TABS 24-2B / D214946
Rehabilitation of the Castleton-On-Hudson
Bridge at MP B1.08
in Albany and Rensselaer Counties

QUESTIONS AND ANSWERS

Supplemental Information to A16

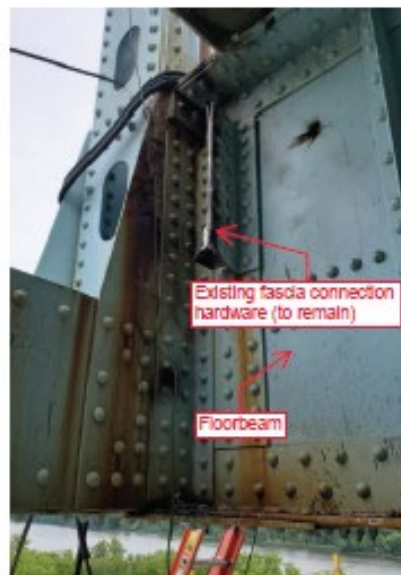
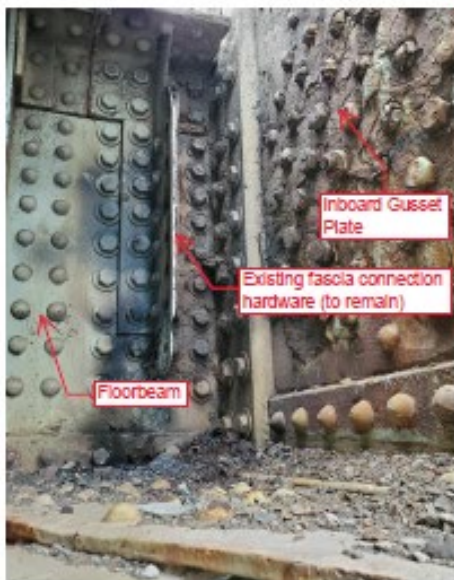
Q16. Please provide details of the truss fascia girder removal at the fixed ends, seated expansion ends, and at the diaphragms. Please show which connection rivets/bolts and elements are to be removed and if the existing diaphragms are to remain or be removed from the 1st interior stringers. Do the connection points to remain require plug bolting, cleaning and painting?

A16. The truss fascia girder is required to be completely removed. Existing connection hardware may remain attached to the floor beams. Existing diaphragms will remain attached to the 1st interior stringers. Plugging existing connection points, cleaning and painting is not required.

Record plans are available to all perspective bidders as supplemental information along with the photos as shown on Page 4. Westbound is shown. Eastbound similar.

Westbound shown, Eastbound similar.
